**THE ENSTROM HELICOPTER CORPORATION**

## **SERVICE DIRECTIVE BULLETIN**

SERVICE DIRECTIVE BULLETIN NO. 0065  
REVISION B  
page 1 of 4

SUBJECT: Tail Rotor Driveshaft Spline Couplings, PN 28-13609

Figure 1. Checking inner spline wear on coupling.

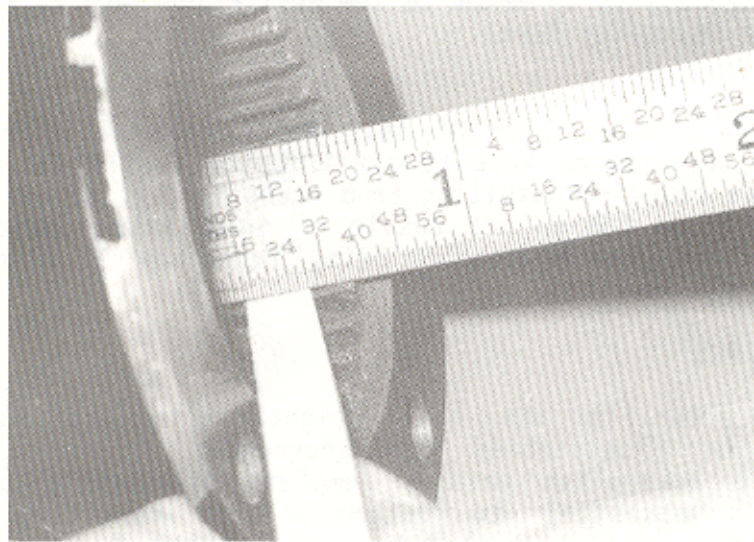
- A. The crown of the female coupling spline is approximately .040 inch in width. If the wear pattern is in excess of .010 inch, it is unairworthy and must be replaced by a serviceable component. The procedure to measure the wear on the female section splines is illustrated in Figure 1.

**NOTE:** Tooth wear is measured by placing a 6 inch steel rule parallel to the crown at the top edge of the driven side. A piece of .125 x .010 inch shim stock is then placed between the tooth and the rule, and pressing the rule against the tooth, check if the shim can be removed. If the shim slips out, the coupling is to be rejected and replaced with an air-worthy component.

Figure 2. Checking outer spline wear on male coupling.

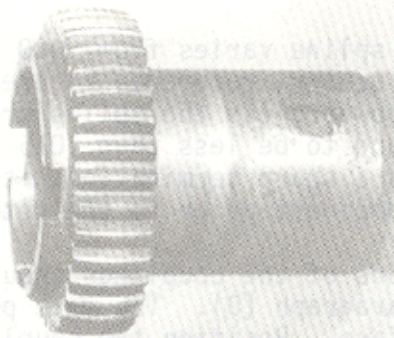
- B. The crown of the male coupling spline varies from .030 inch at the ends to approximately .020 inch at the center, reference Figure 2. By using a steel 1/100ths scale and a 10 power glass the spline crown should be measured at the center. If found to be less than .015 inch, and has rolled burrs on its edge or has a sharp termination, it must be rejected and replaced by an airworthy component prior to the return to service.

Figure 3.  
Checking hardness on male  
portion of coupling.

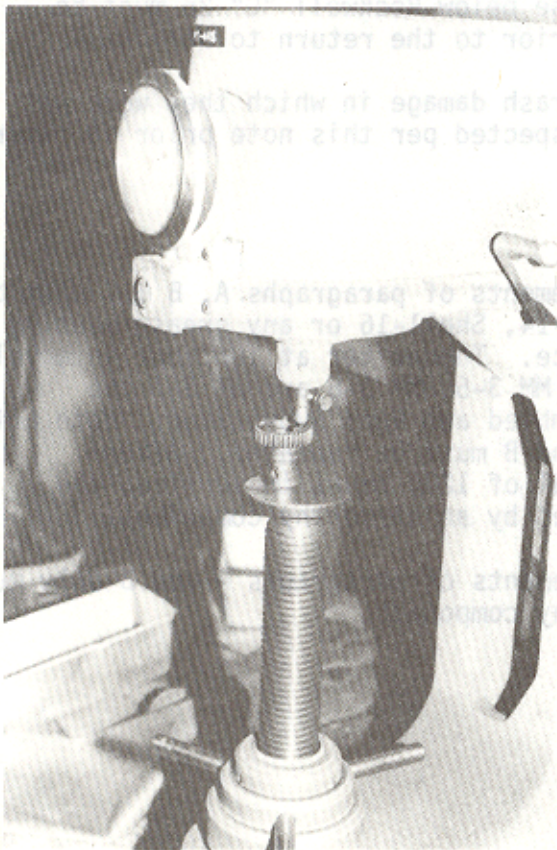
- C. Both the male and female portions of the couplings should be checked for material hardness, reference paragraph (D). The male portion should be checked on the inner circular face. Position the coupling half with the splined end and inner face looking up on the Rockwell machine support mandrel, making the inner face accessible, reference Figure 3. The female portion should be placed with its inner diameter over the mandrel and the attaching stub facing up. The end of the stub should be checked, reference Figure 4. Care should be taken when checking the hardness to properly support the components, and the surfaces to be checked should be clean and smooth. Three readings should be made on each half to obtain a good average on the Rockwell "C" scale. Components that average Rockwell "C" 25 or higher are acceptable; those below Rockwell "C" 25 must be replaced by an airworthy component prior to the return to service.
